GULF STATES UTILITIES COMPANY

River Bend Station-Unit 1
Docket No. 50-458

Enclosed is the Gulf States Utilities Company (GSU) response to Safety Evaluation Report (SER) Confirmatory Item #19 - Hydrogen Control (SER Section 6.2.5, Page 6-32/33.) Attachment 1 contains the GSU endorsements for various Hydrogen Control Owners Group (HCOG) submittals. These letters should be utilized to provide background and reference material for SER Confirmatory Item #19. Attachment 2 contains a revision to the Request for Additional Information (RAI) on the Hydrogen Ignition System (HIS) transmitted to W. J. Cahill (GSU) by A. Schwencer (Nuclear Regulatory Commission - NRC) on December 2, 1983 and supercedes the original GSU response from J. E. Booker (GSU) to H. R. Denton (NRC) dated December 30, 1983 (GSU Letter No. RBG-16679).

REQUEST FOR ADDITIONAL INFORMATION FOR USE IN THE EVALUATION OF
THE HYDROGEN IGNITION SYSTEM FOR THE RIVER BEND STATION, UNIT 1
MARK III CONTAINMENT

PAGE 8 of 11

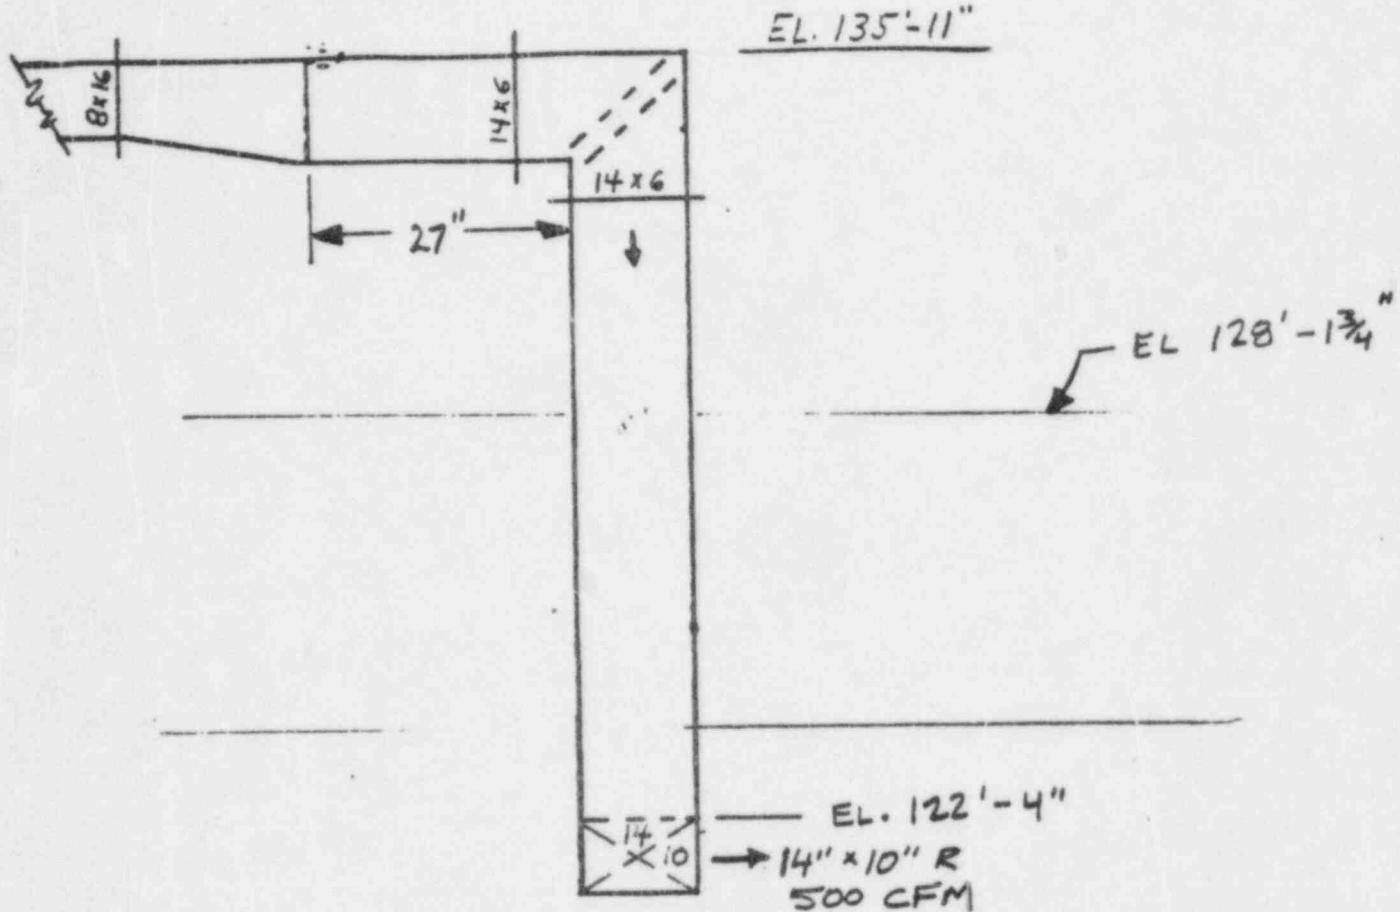
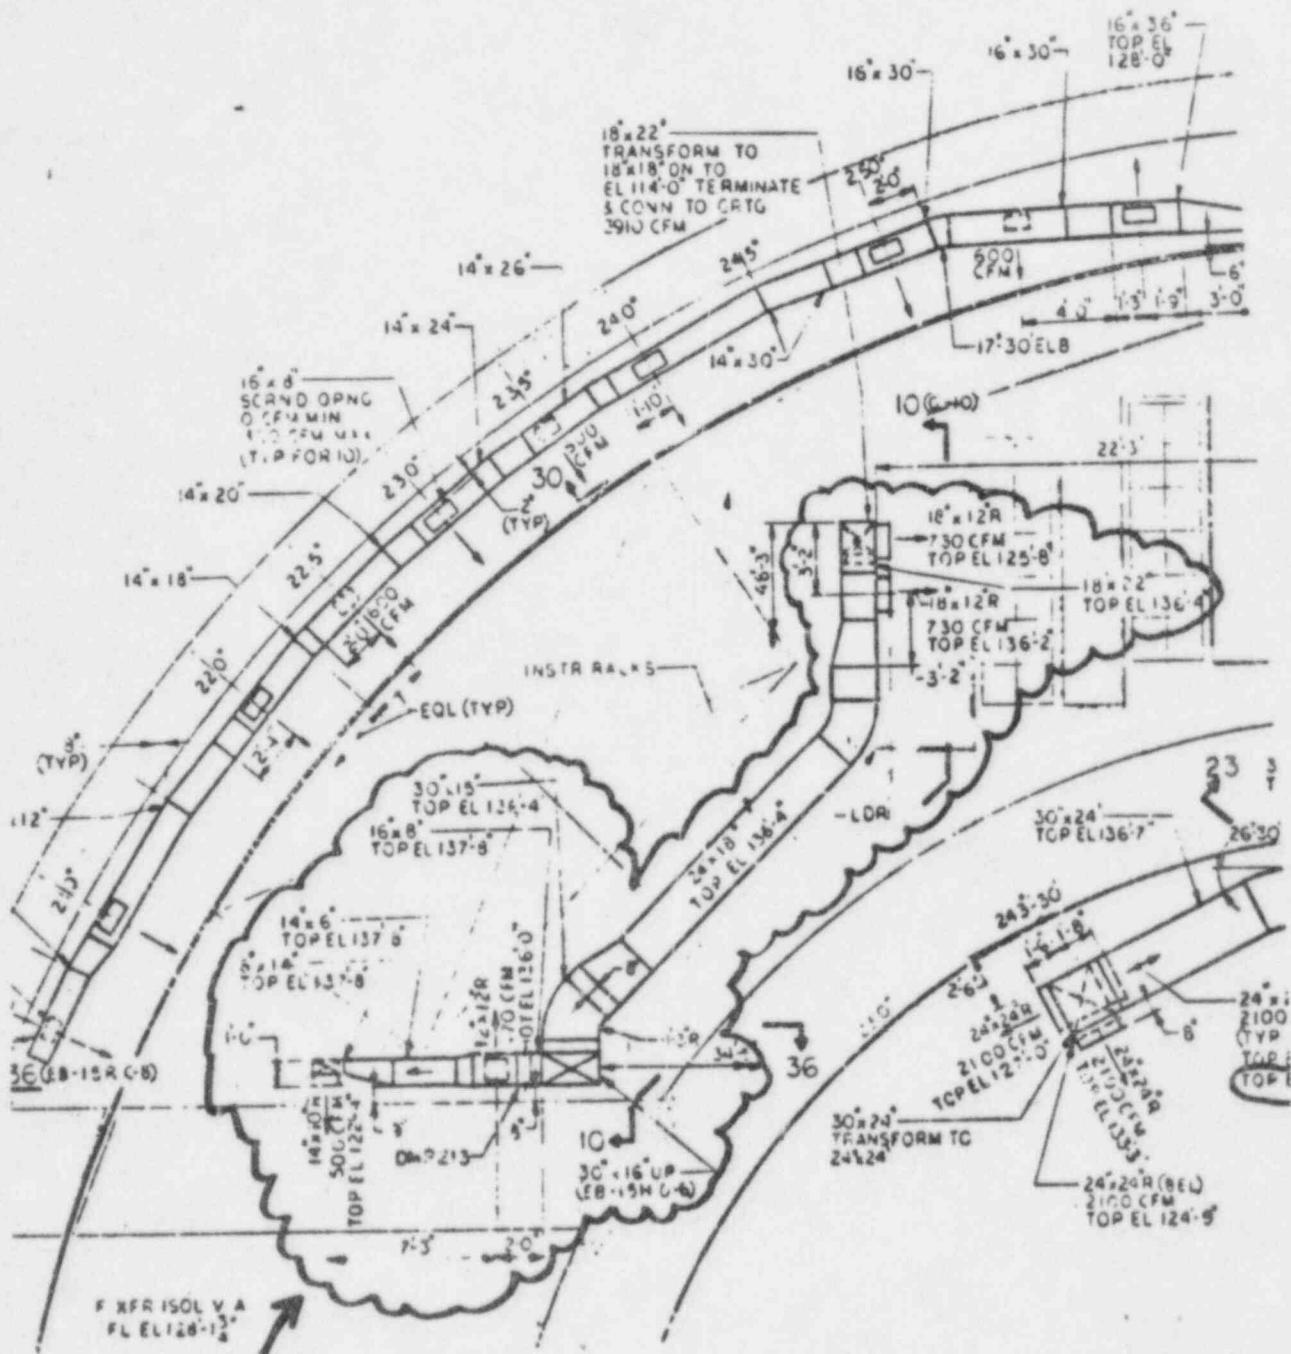
SEE SKETCH ON PAGE TWO FOR TENTATIVE DUCTWORK RELOCATIONS.
 DESIGN DWGS. EB-15F AND EB-15R WILL BE REVISED DEPICTING THE AS-BUILT CONFIGURATION.

EB-15F AND 15R SHALL BE REVISED INCORPORATING THE INFORMATION CONTAINED ON PAGES 4 THRU 8 OF THIS E&DCR.

THIS DUCT SYSTEM SHALL BE CHANGED
AS SHOWN ON PAGES 4 THRU 8
OF THIS E&DCR

REF.: EB-15 H -8

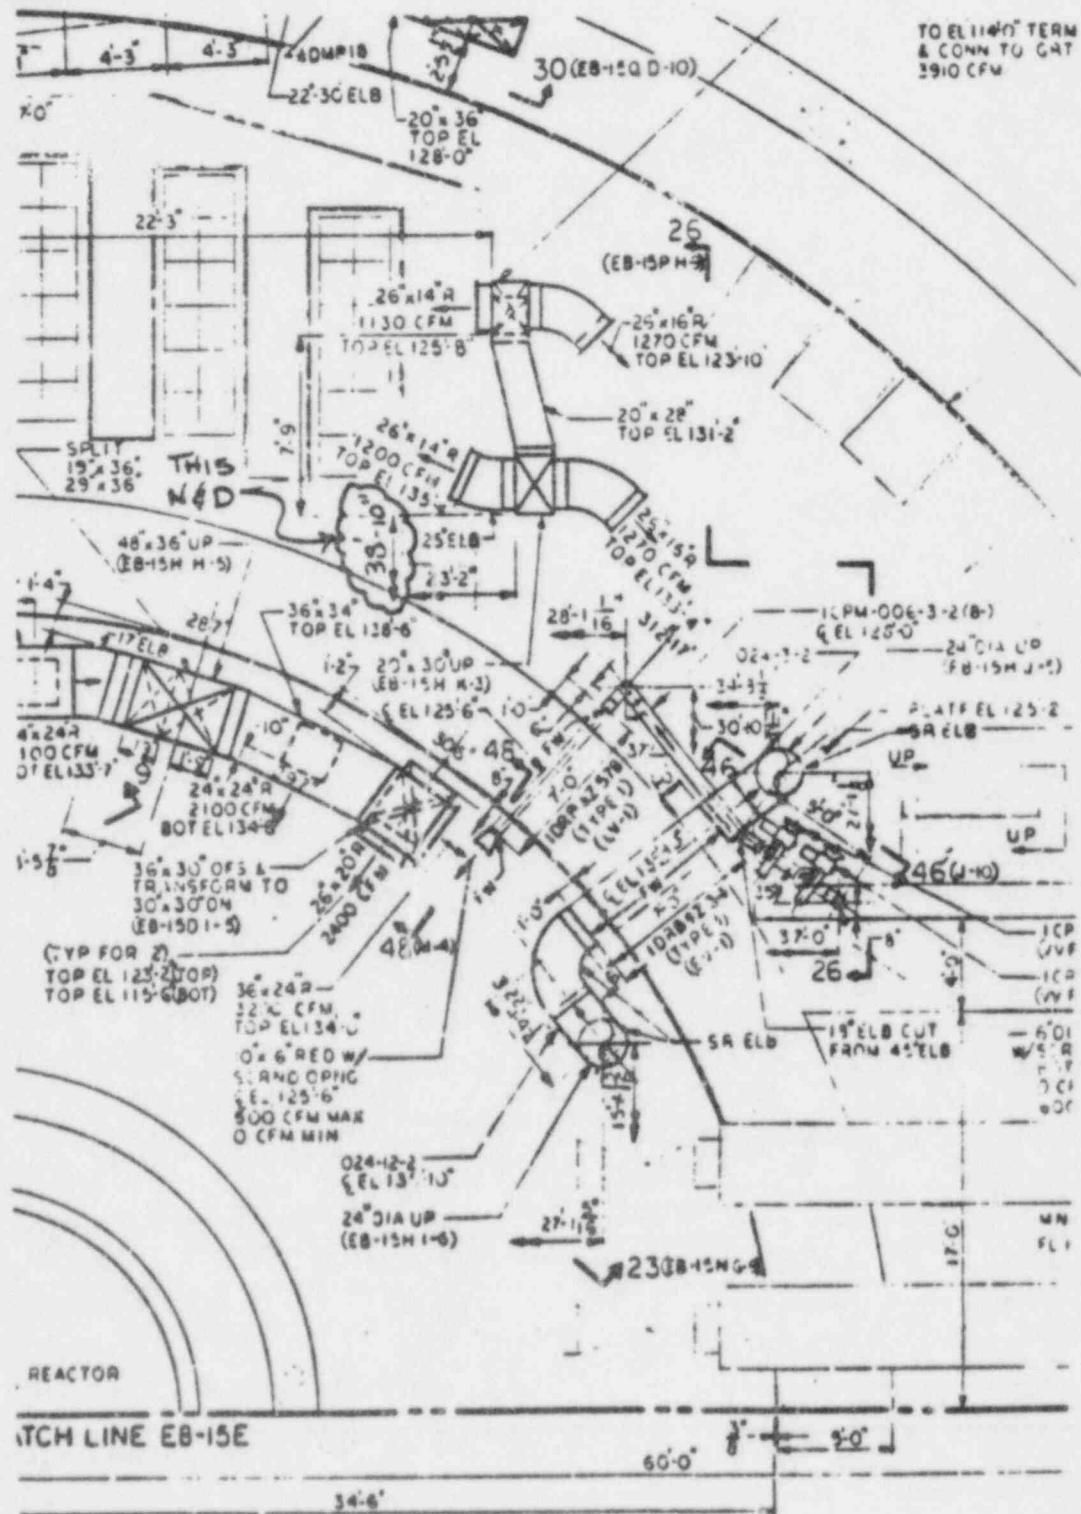
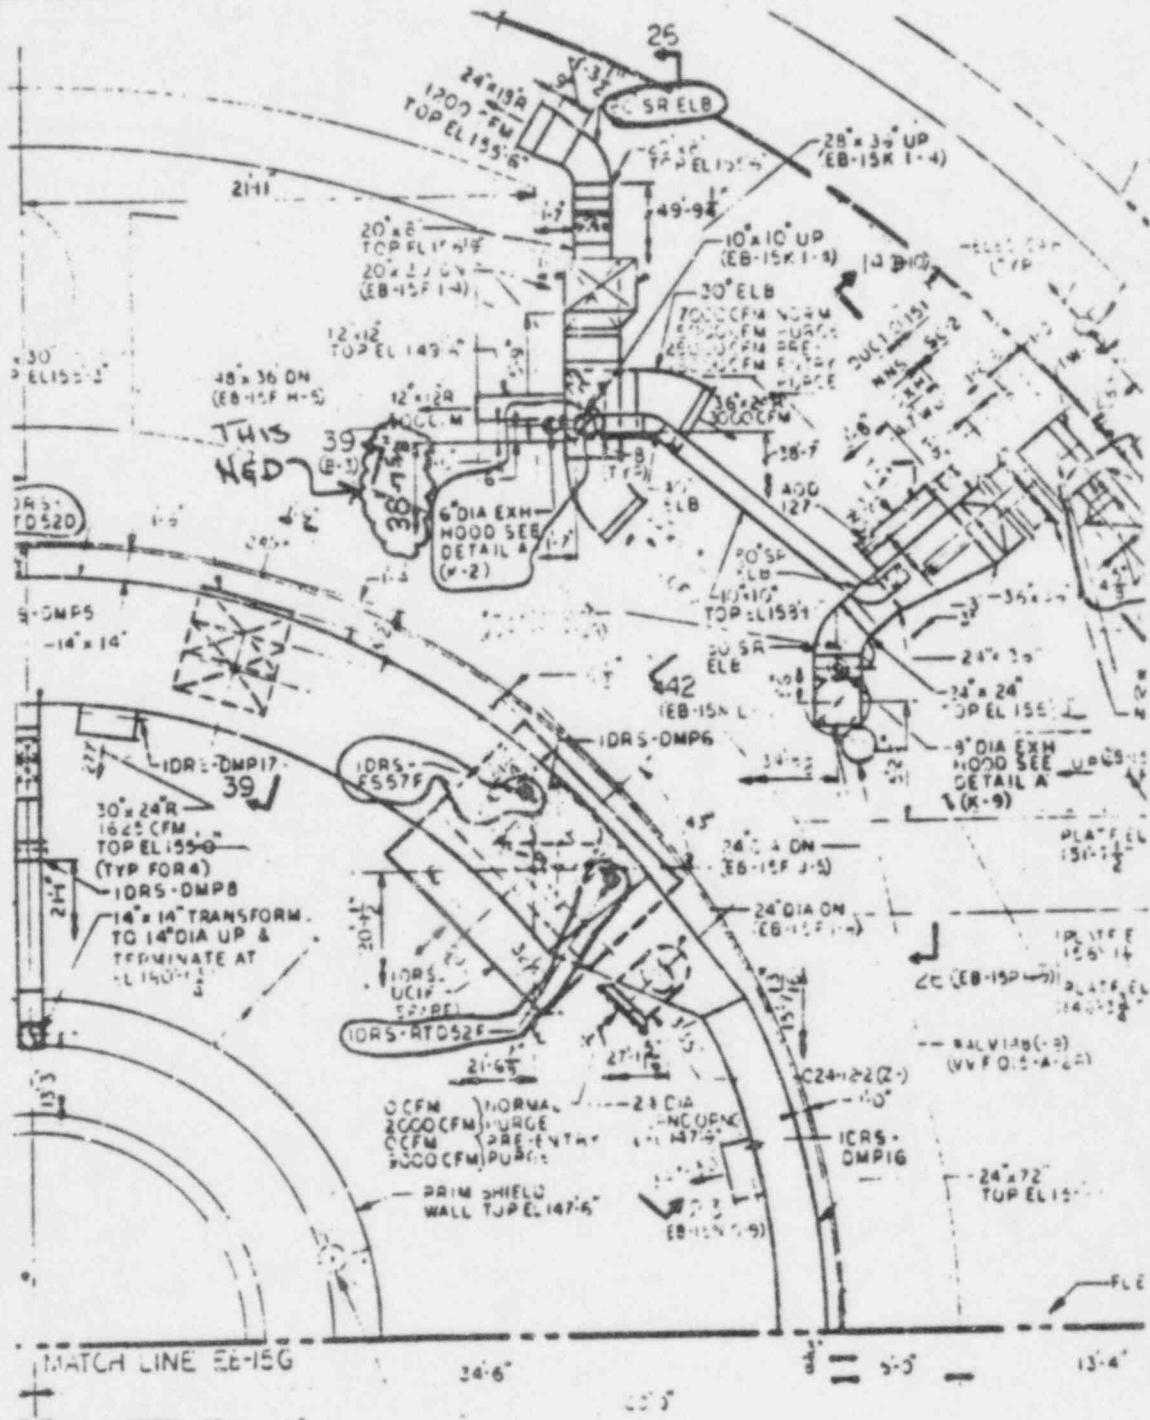
CONDITION DETAILS THE DUCT RISER IN THE REACTOR CONTAINMENT BETWEEN 19. AZIMUTH 287° AND 306° @ EL 155'-6" DOWN TO EL 114'-0" IS OFF LOCATION. THE EB DRAWINGS (EB-15F & 15H) SHOWN THE DUCT TO BE 38'-6" EAST OF THE CENTER LINE OF THE REACTOR. AS BUILT MEASUREMENTS SHOW THE RISER TO BE ~~38'-7 1/8"~~ ^{38'-7 1/8"} @ 155'-6 EL. AND 38'-10" @ 131'-2" EL. EAST OF THE CENTER LINE OF THE REACTOR.

22. ACCEPT-AS-IS : REVISE EB-15 F&H AS SHOWN ON PAGES 2 & 3 OF THIS N.D.

THE CHANGE IN LOCATION WILL NOT EFFECT THE FUNCTION OF THE DUCT SYSTEM.

EB-15G-8

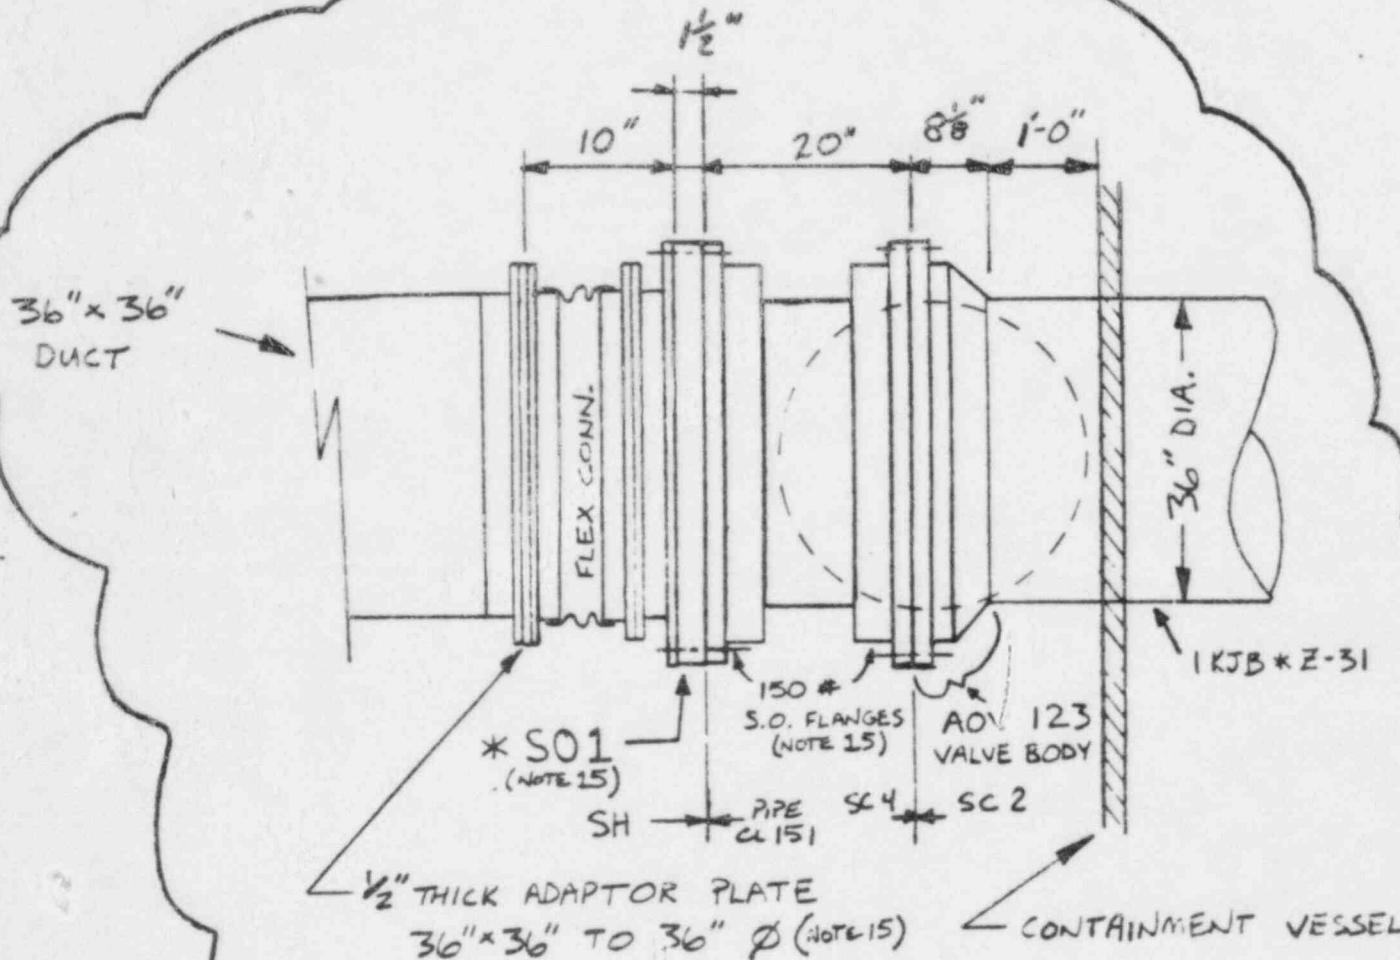
EB DWG. #	EDCR PAGE #	DESCRIPTION OF CHANGE
EB-15G	2 OF 7	PLAN VIEW @ 35°
EB-15G	3 OF 7	REPLACES SECTION 13-13
EB-15H	4 OF 7	PLAN VIEW @ 320°
EB-15H N BS. 3/2/84	5 OF 7	ADD NEW SECTION 57-57
EB-15N	6 OF 7	REVISES SECTION 42-42
EB-15R	7 OF 7	ADD NEW NOTE 15

REPLACE EXISTING SECTION 13-13
